ADDENDUM NO. 2

Reference: Student Activity Center Addition to the Stromberg Athletic Complex
Weber State University – Ogden, Utah
DFCM Project No. 12031810

Addendum 002

project:	WSU Stromberg Student Activity Center	**project no:**	12475
date:	2012-10-15	**no. pages:**	75
owner:	DFCM		
contractor:			
bid date:	2012-11-01	**bid time:**	12:00 pm

S142

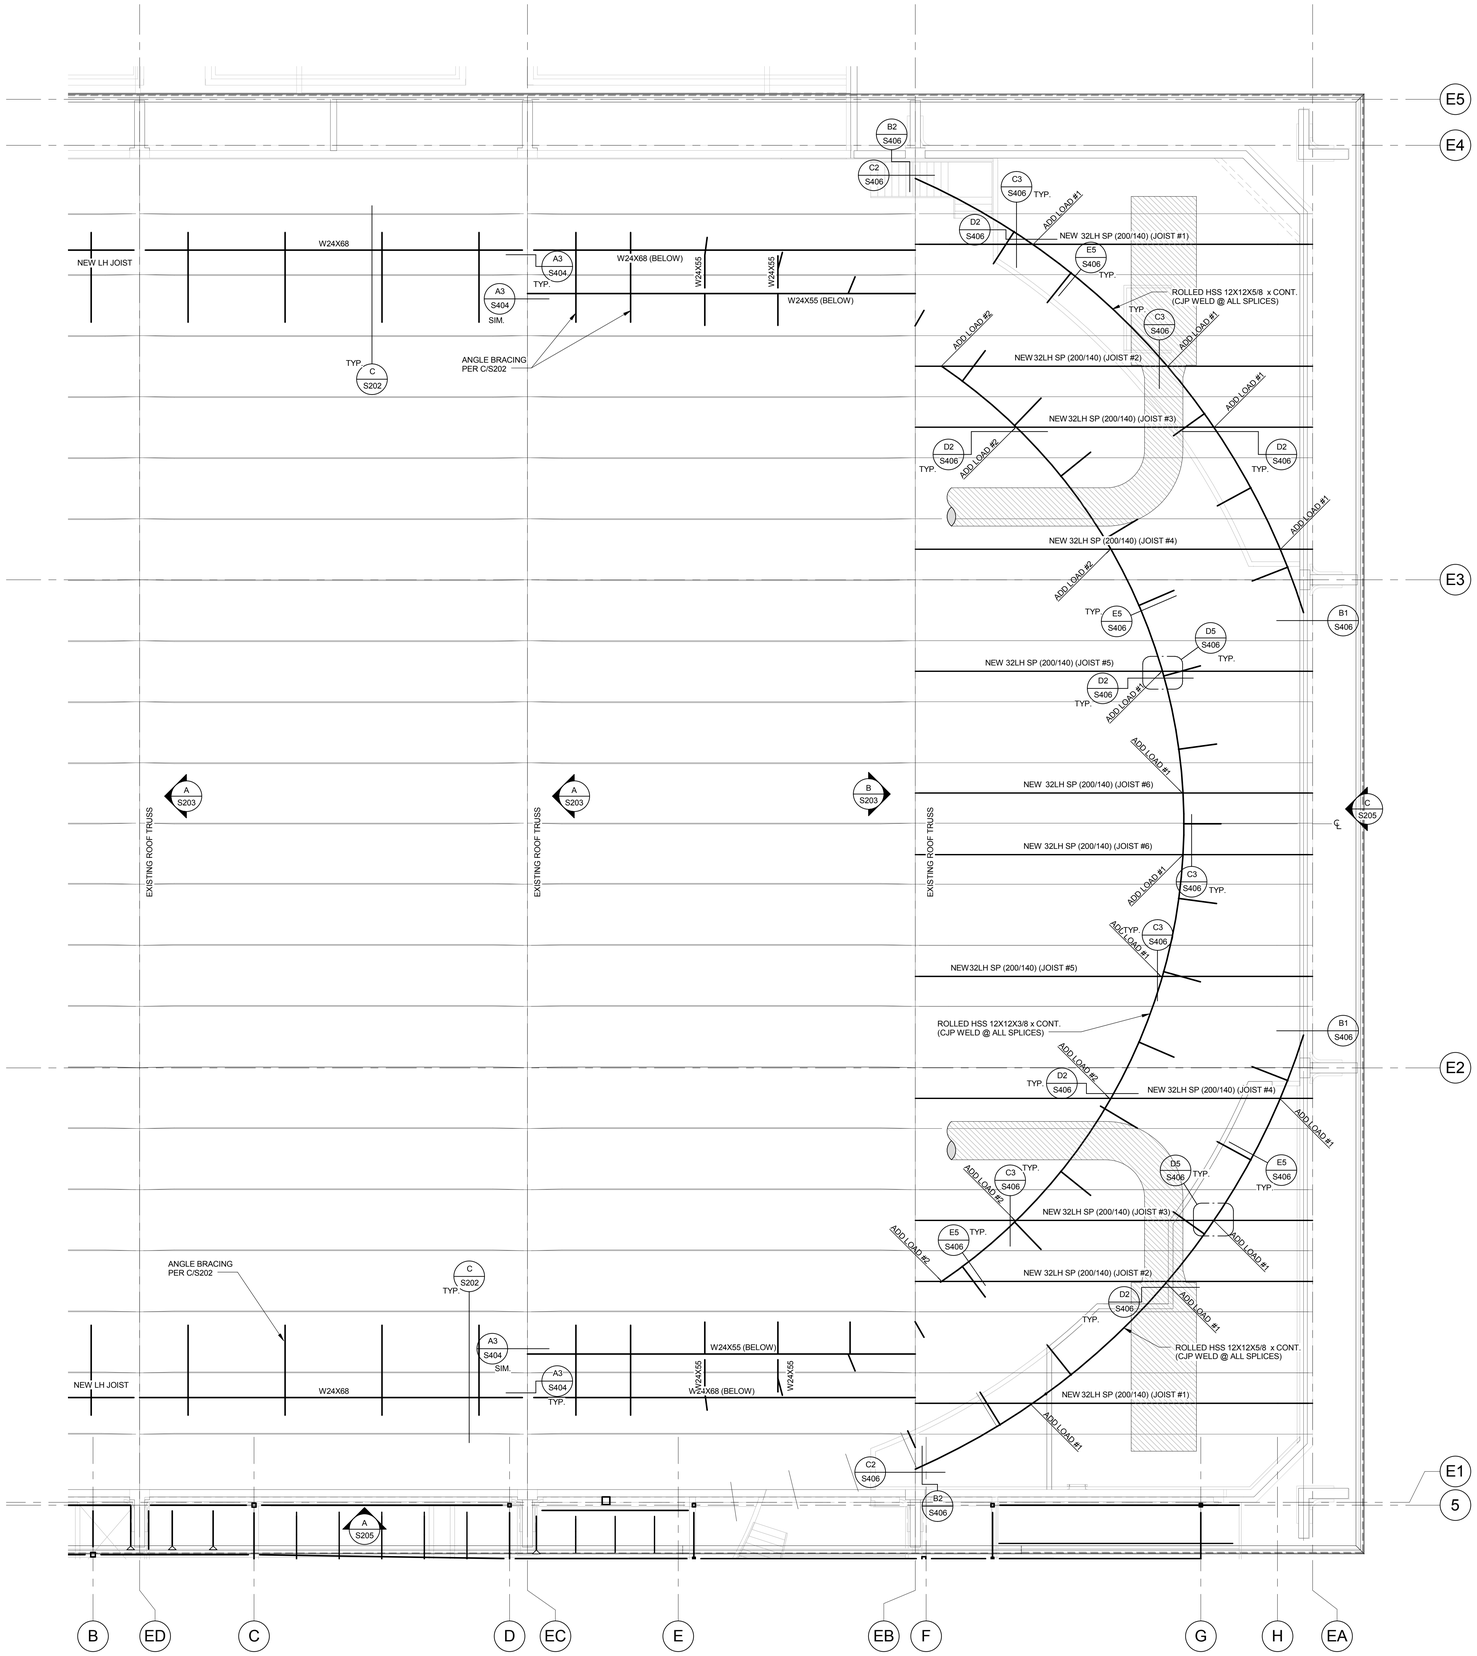
Sheet S142
- A note has been added referring to S142.1 for roof upgrades.

ROOF FRAMING PLAN - AREA B

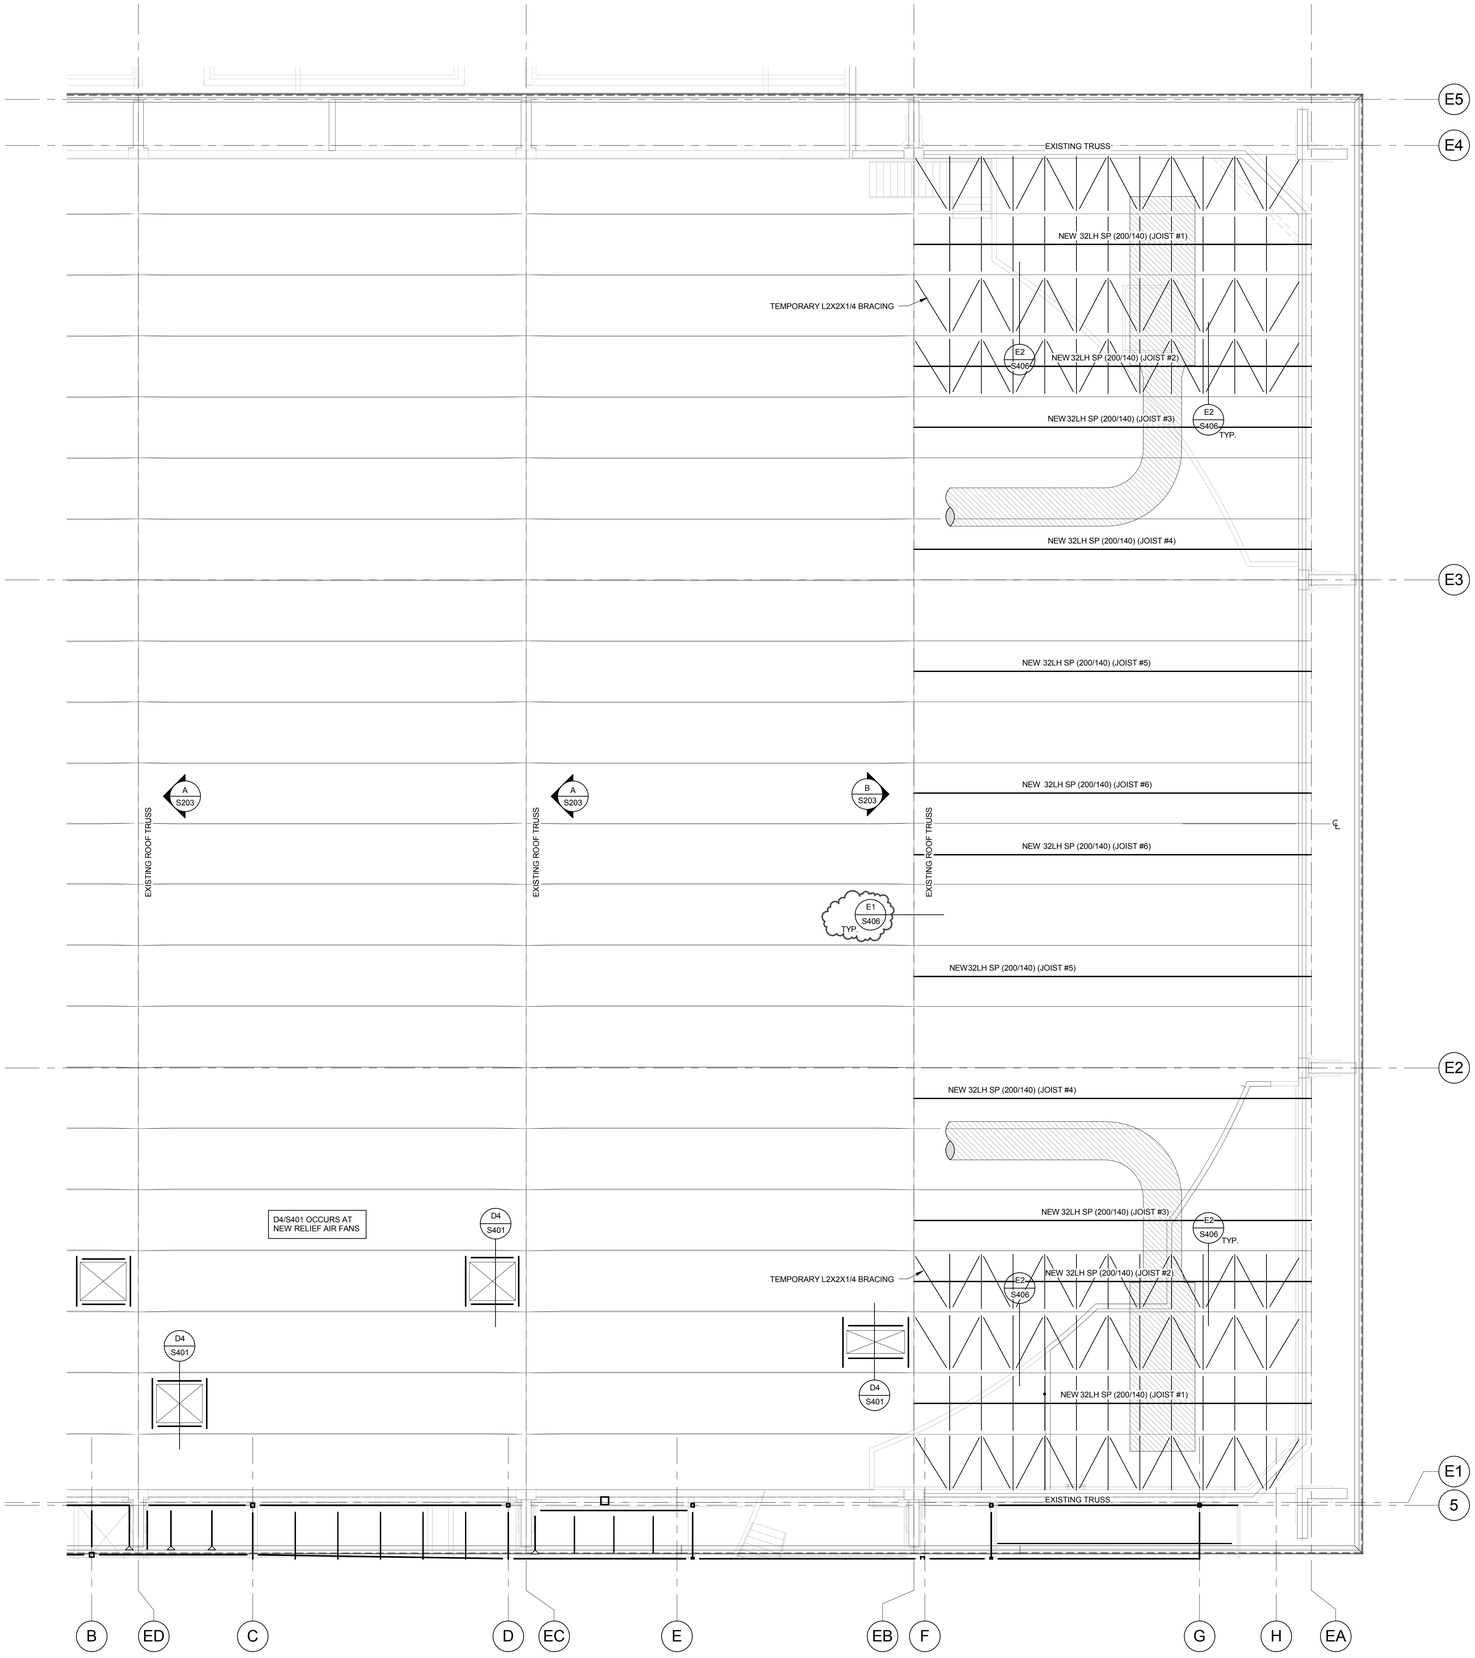
Sheet S142.1
- A detail cut has been added along gridline EB.

ROOF FRAMING PLAN - AREA C

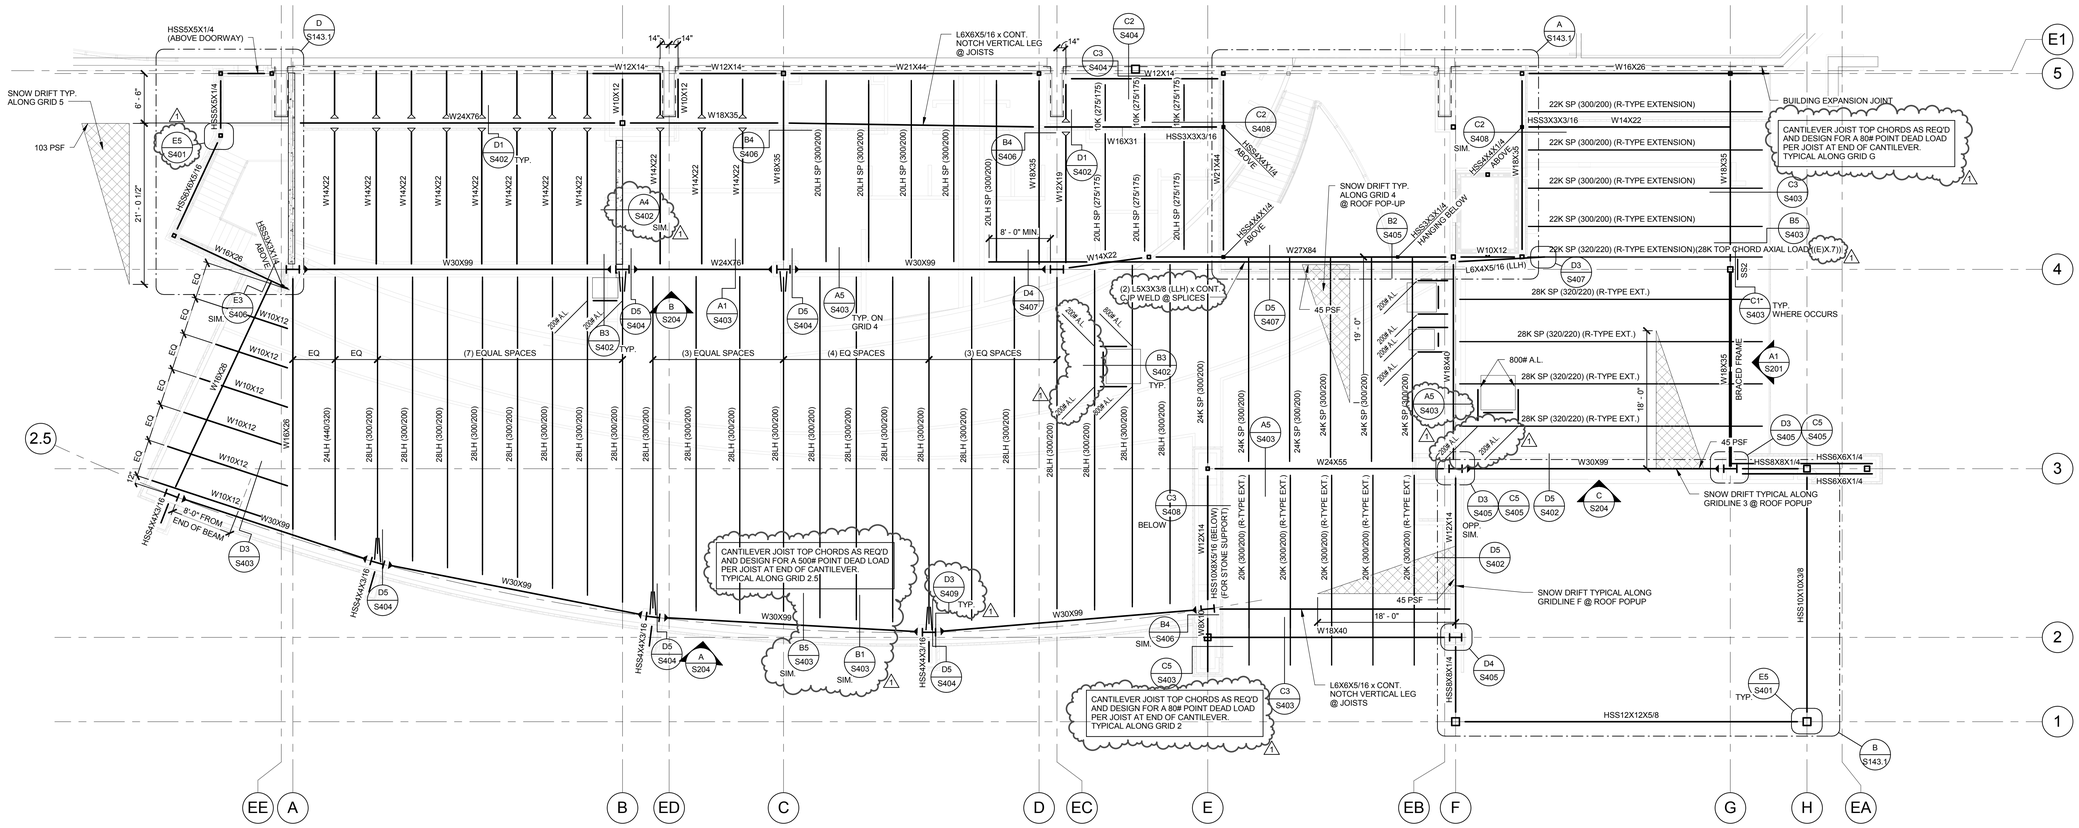
Sheet S143
-Wind net wind uplift design force has been revised in the framing notes.
-Note 16 has been added.
-Add loads have been added at joist cantilever and for some mechanical equipment.
-A detail cut has been added at gridline B.
-The L5x3x3/8 collector angle at E-4 has been clarified.
-The design load for the joist at 4 between F and G has been clarified.

S143.1

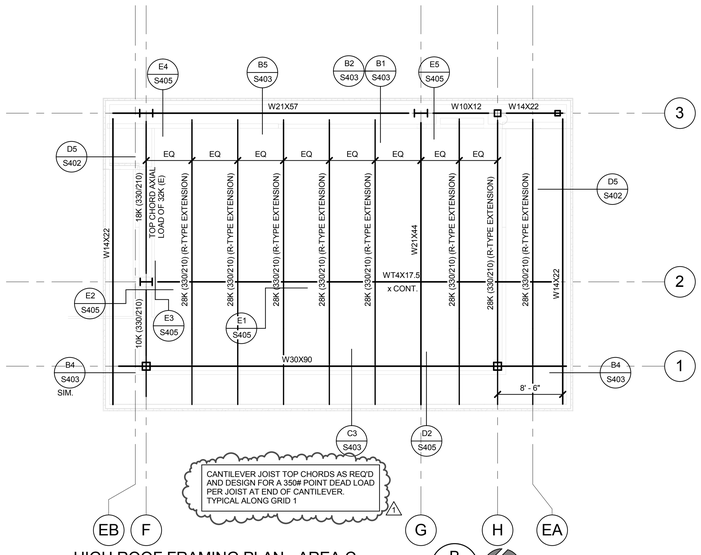
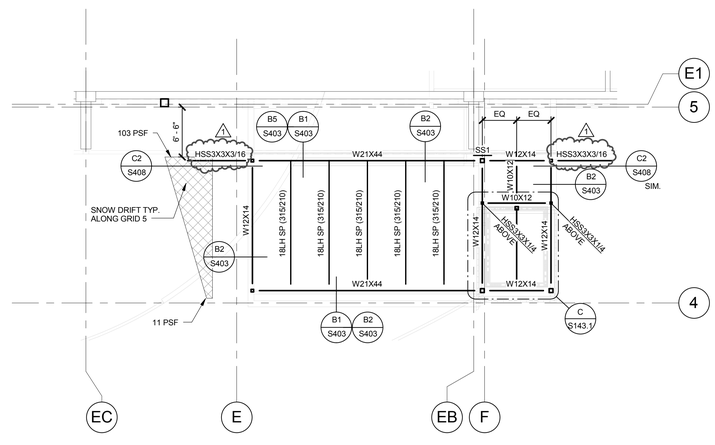
Sheet S143.1
-An HSS callout has been added for the chord strut in A/S143.1.
-Joist cantilever design loads have been provided in B/S143.1.
-A redundant detail cut along gridline 1 has been removed from B/S143.1.

S203

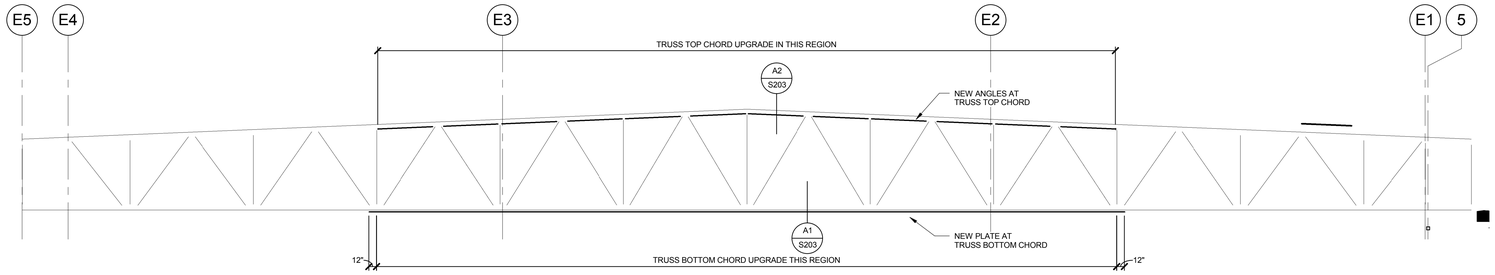
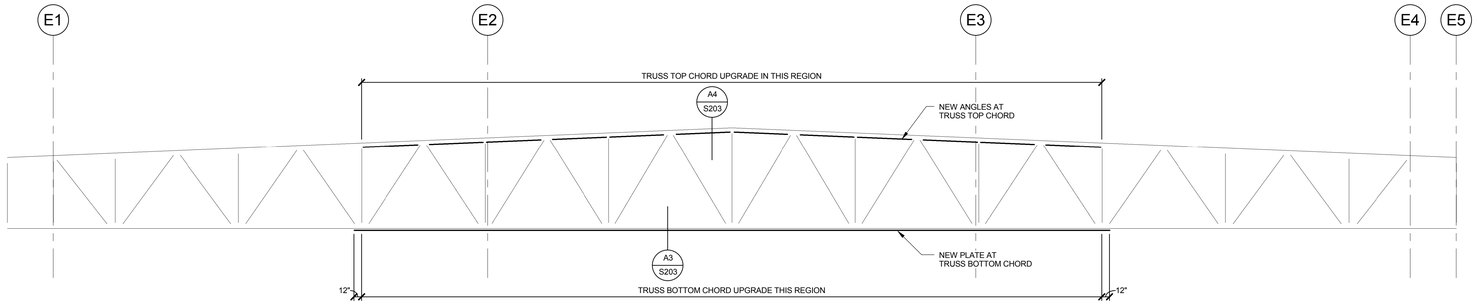
Sheet S203
-Weld requirements have been clarified at details A1 and A3.

WEST ELEVATION WALL UPGRADE
SCALE : 1" = 10'-0"
A
S205

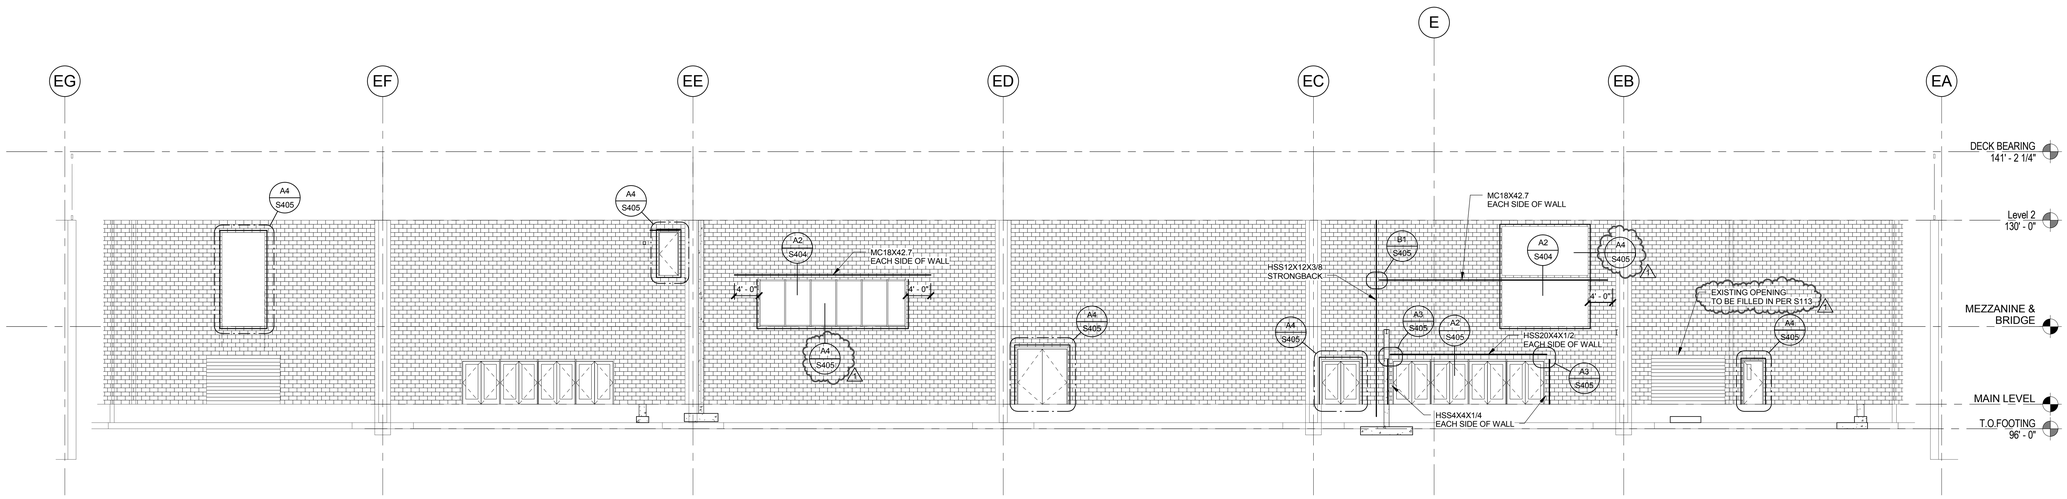
Sheet S205
-Detail callouts and a general clarification have been added to A/S205.

DETAIL C3/S408
SCALE : NONE

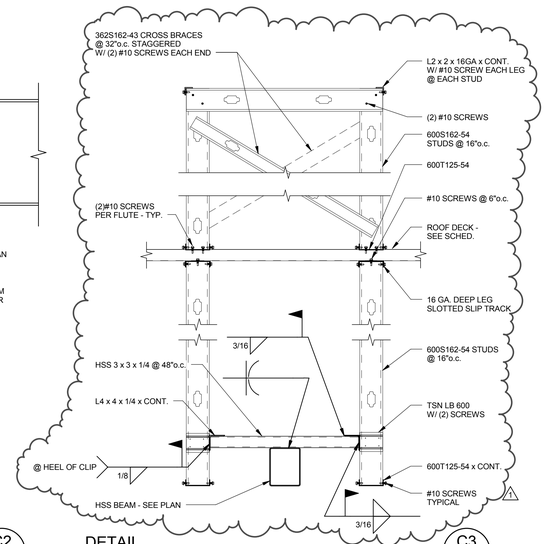
-Weld requirements have been added to details B2 and B3.
-Detail C3 has been revised.
-Details B4 and B5 are new details.
